Determination 2018/034

The refusal of a code compliance certificate for an addition at 42 Harley Close, Hauraki, Auckland

Figure 3: Approximate site plan

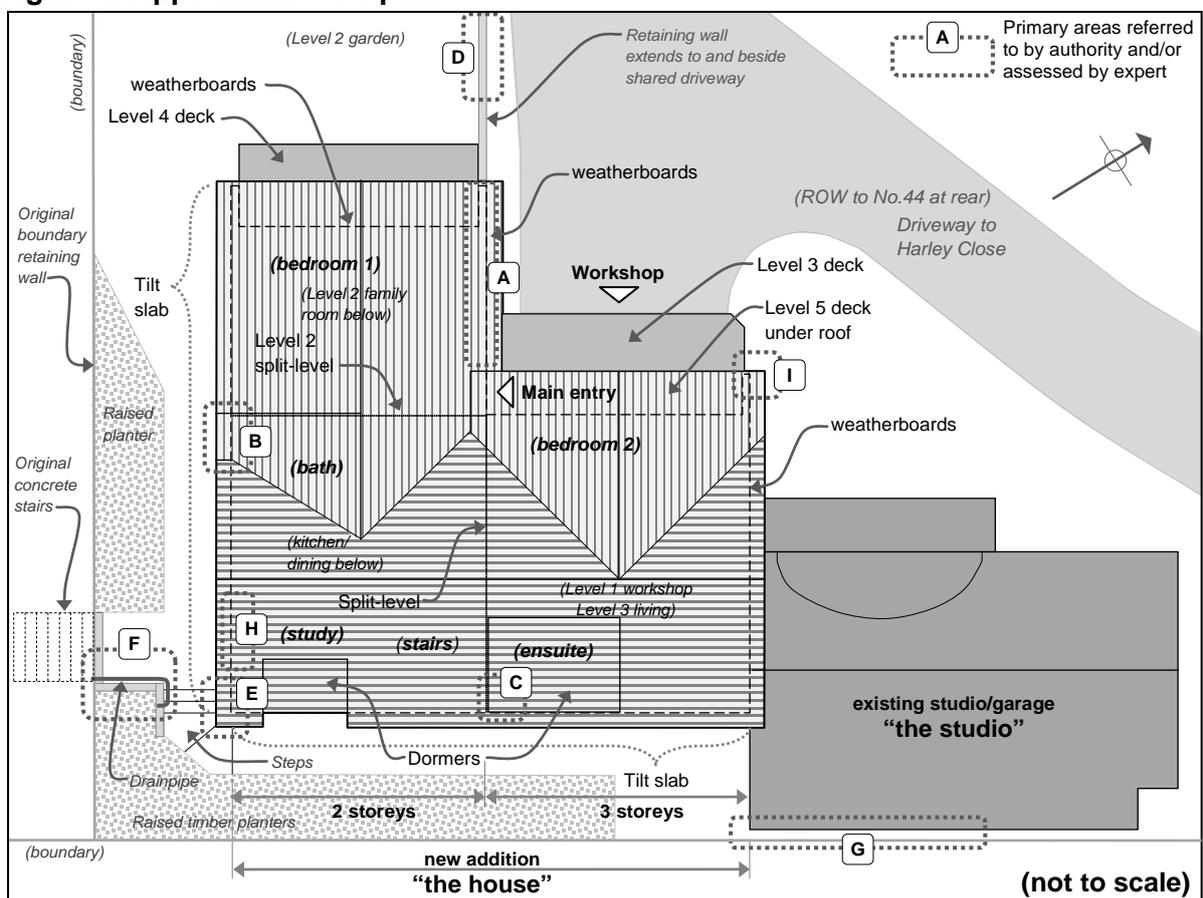
- Item 1: documentation required for:
 - the stone facade (Area A)
 - gable end change to southwest (Area B)
 - upper floor ensuite layout change (Area C)
- Item 2: lack of barrier to top of stone retaining wall (Area D)
- Item 3: non-compliant hand rail to back steps (Area E)
- Item 4: the inadequate flashing to top of stone facade (Area A)
- Item 5: “storm water from the neighbouring property needs to be reconnected” (Area F)
- Item 6: “vermin proof the upper level [ensuite] vanity” (Area C)
- Item 7: “seal the kitchen cabinets to ground level”

- stone facade direct-fixed to northwest sub-floor concrete foundation wall (Area A)
 - alteration to roof above southwest Level 4 bathroom (Area B)
 - alteration to Level 5 ensuite layout (Area C).

4.2.5 Item 5 – Retaining wall drain (Area F): In regard to the drain, the expert noted that:

- a small insitu concrete wall had been built to stem the flow of water through the boundary retaining wall. The drain had been installed to collect ground water from behind the boundary retaining wall and redirect to a point where it could flow to the west corner of the applicant's property (see Figure 3)
- despite a severe storm with considerable rain the night before the expert's site inspection, no water flow was observed from the drainpipe, and only minor seepage was observed from the original retaining wall/stairs
- a slotted polyethylene field drain has apparently been installed along the base of the boundary retaining walls to collect water and direct it into the drain to the northwest
- the ground appears fairly free draining and firm; and drainage appears to be coping adequately, with no significant impact on the consented work.

- “[The] flashing identified as Item 4 ... would be failed by “[the authority]”
- The applicant “has carried out unconsented drainage work associated with the retaining wall [Item 5] which it is understood the applicant says was necessitated by the consented building work. The net effect is that the relevant drainage has been re-directed so as to adversely affect other property contrary to cl. B1.3.6(b)”.

- (Item 4) a flashing was not considered necessary at this location. The stone veneer is attached to a concrete foundation wall (either block or precast panel) and the top of the veneer finishes below a concrete slab floor on grade. The left hand end of the of the veneer was sheltered.
- (Item 5) the applicant advised the expert that:
 - additional drainage had been installed around the property to resolve the surface water problem. In the expert’s view the redirected pipe was not adversely affecting other property and in any event the water would run back into 42 Harley Close. The redirected water did not appear to be affecting the retaining wall structure. The site visit took place immediately after a significant rain event and no surface water problems were noted.

- 5.2.4 In respect of the drainage to the retaining wall I accept the expert's view of the matter in that:
- Significant work separate from the consent has been done by the applicant to address issues related to water runoff from adjacent properties. This work appeared to be effective.

- The retaining wall drain is minor, and in any event water discharging from the wall will run back to the applicant's property without affecting the neighbour's wall. Very little water was seen draining from the pipe despite significant rain falling in the period immediately before the site visit.

- The retaining wall drain has no significant adverse impact on the consented work.
- 5.2.5 The retaining wall drain is not shown in the approved consent plans, nor is any other site drainage apart from the connection of downpipes and the corresponding surface water drains. I accept that the retaining wall drain was not part of the consented work but it has been modified during the execution of the consented work – the installation of the drain was part of a wider ongoing dispute that was quite separate to the consented work. If the authority considers work has been carried out that required a building consent it can pursue that matter separate to the issue of the code compliance certificate for the consented work.
